# Technical Service Bulletin

## 20 Noises from the fuel line

20 24 70 2059997/6 July 3, 2024. Supersedes Technical Service Bulletin Group 20 number 24-66 dated February 19, 2024 for reasons listed below.

Model(s)	Year	VIN Range	Vehicle-Specific Equipment
Q3	2019 - 2025	All	Not Applicable

**Figure 1.** Location of the vibrating fuel line.

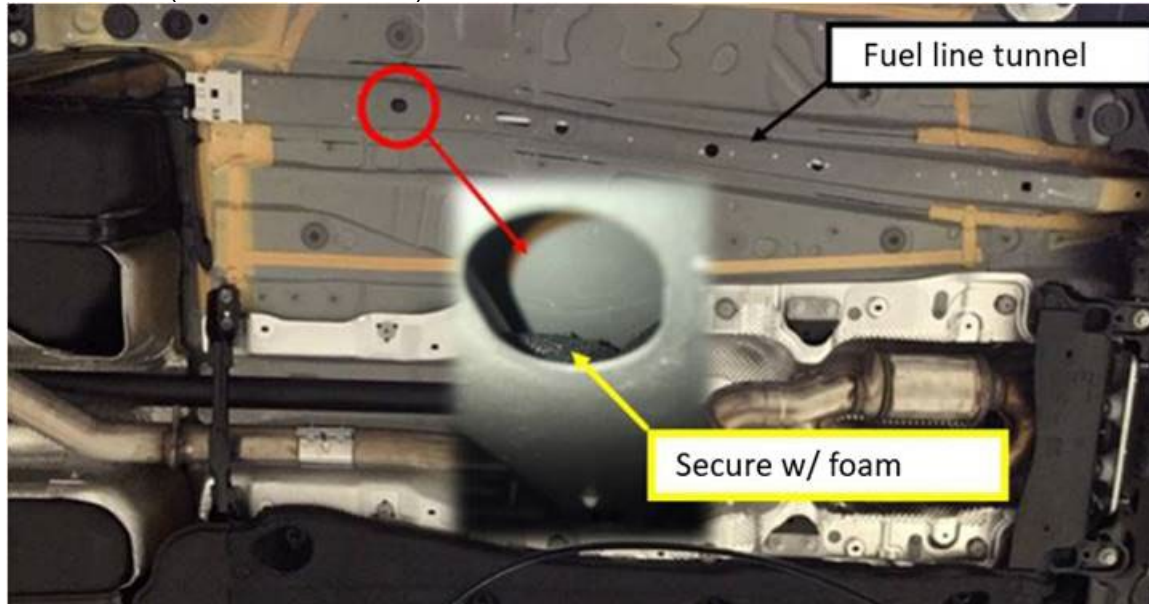
Due to pressure pulsation from the high-pressure pump on engine side the underfloor line in the underbody tunnel vibrates. This vibration causes noise that can also be heard in the vehicle interior.

2. Fill the area around the fuel line with closed-cell foam or use existing workshop materials (e.g., WHT.008.974, not water-absorbent) This way, the fuel circuit does not need to be removed. If this does not work, use e.g., 06A141730A (toothed lock washer).
